Project 9 Heath House Farm, Bent Lane, Church Broughton DE65 5BA
Drawing Title Proposed Detailed Section D - D

Date	Job No.	Drawing No.	Revision
Sep'19	19/638/ F03	A

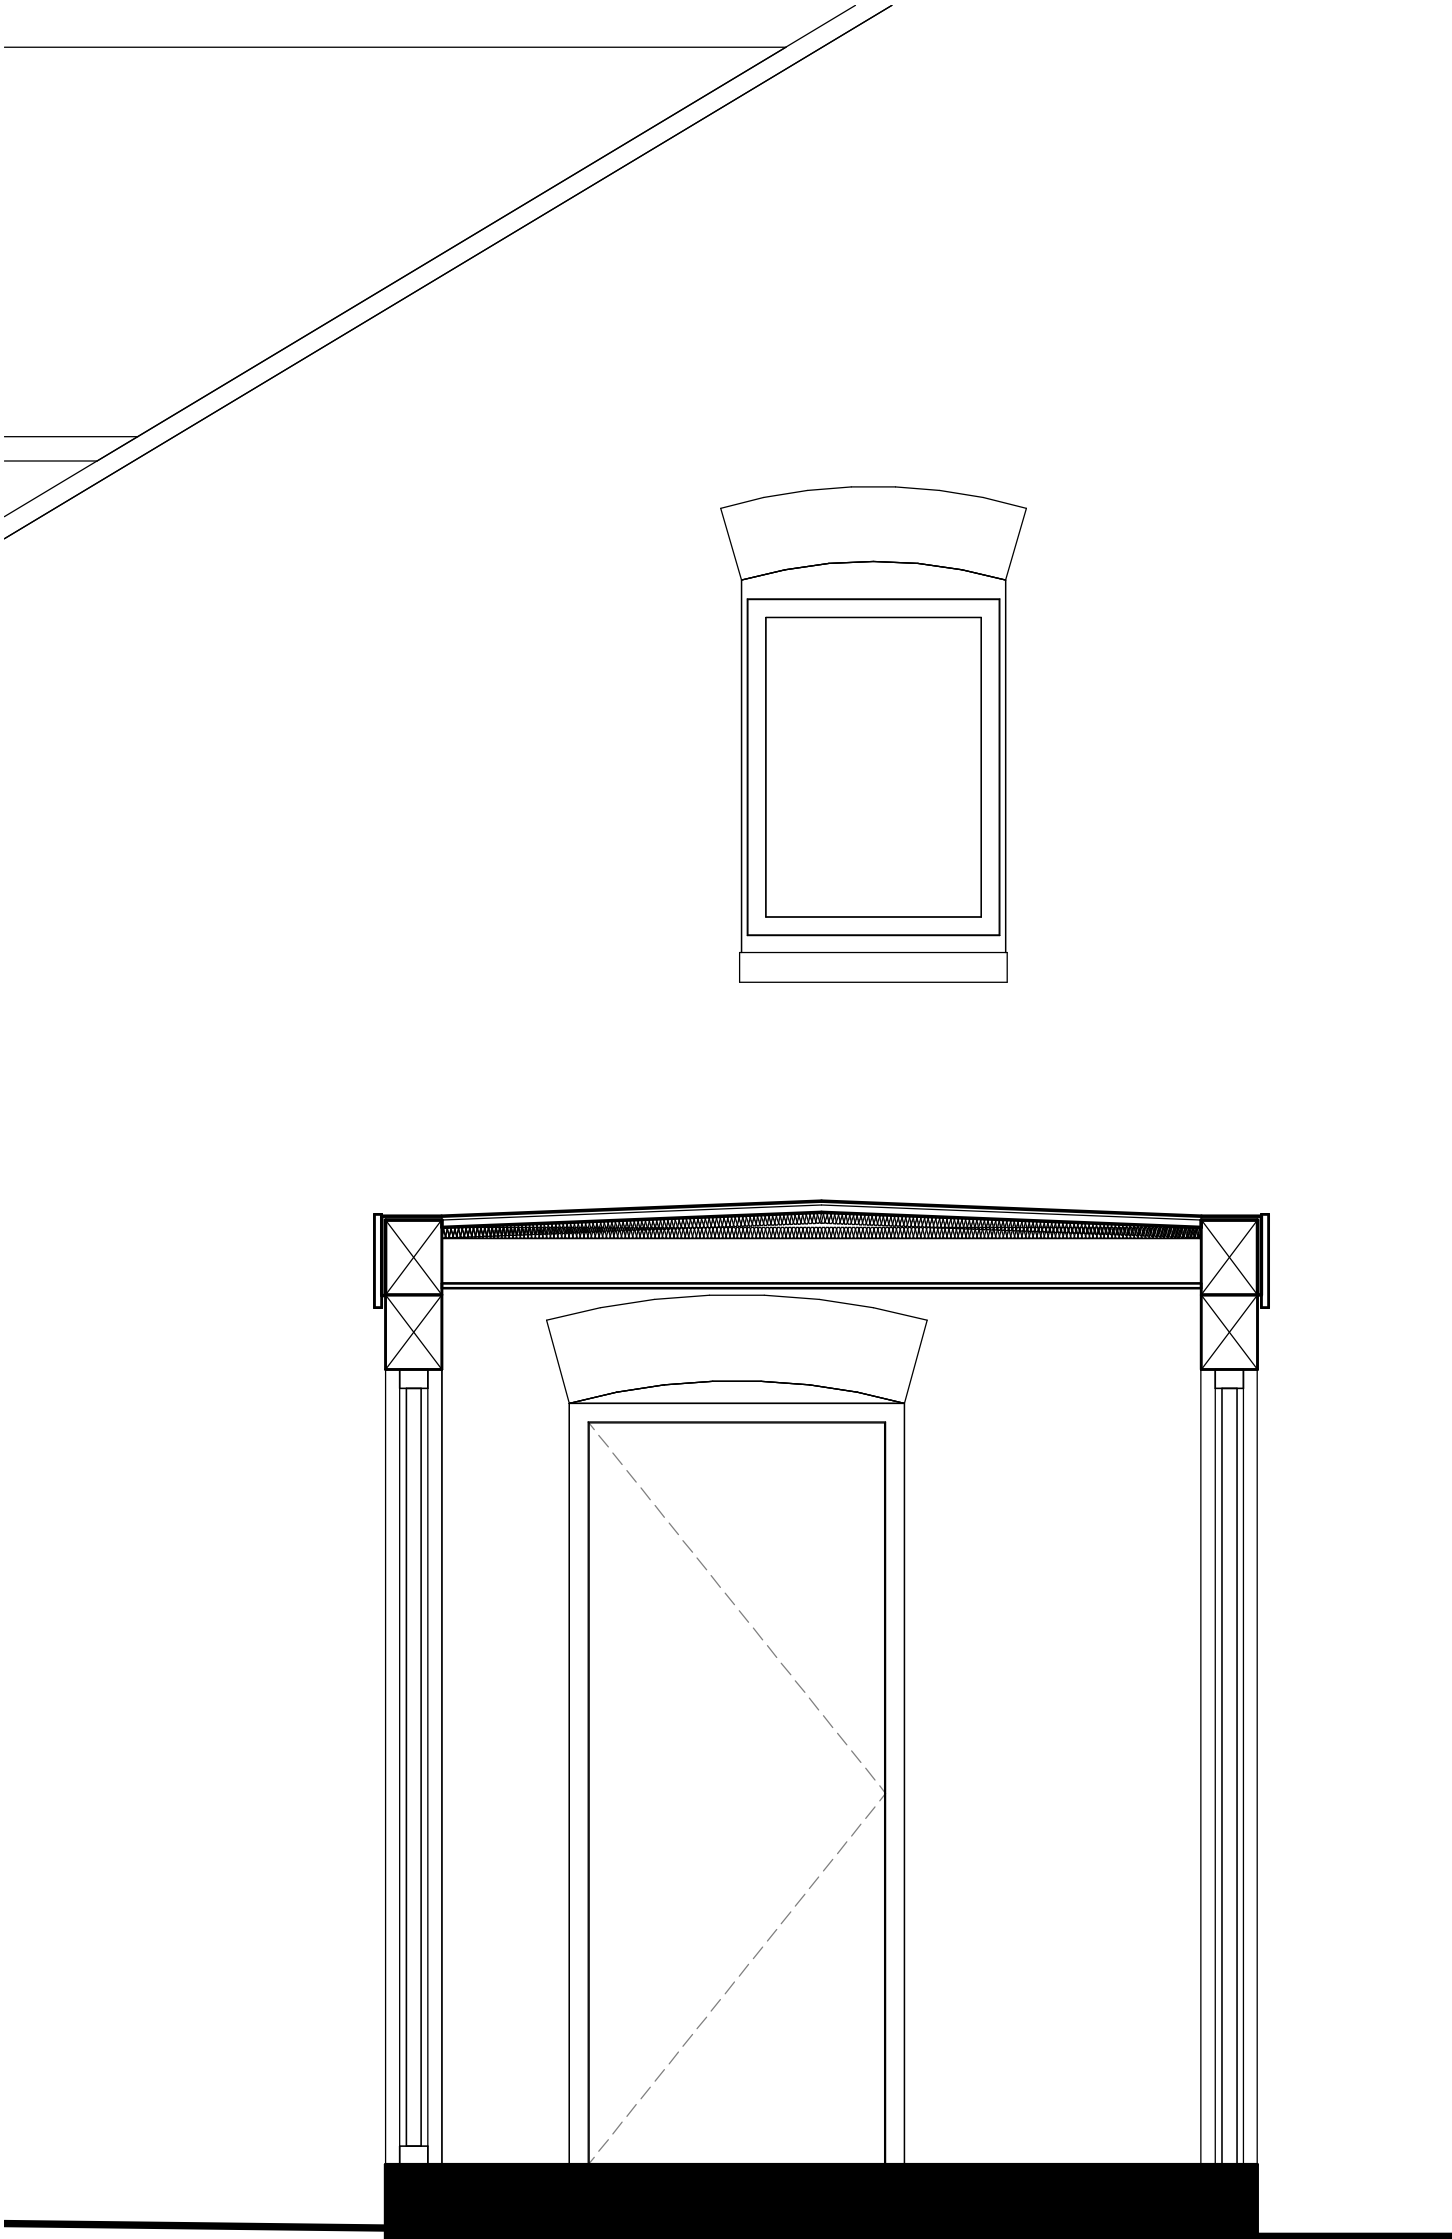
A	Skylights Added To Garden Room And Utility Room. Garden Room BiFold Doors Added To Entire Run At Gable End. 2/3 BiFold Doors Added To Side Of Garden Room.	16/09/19
Rev	Note	Date
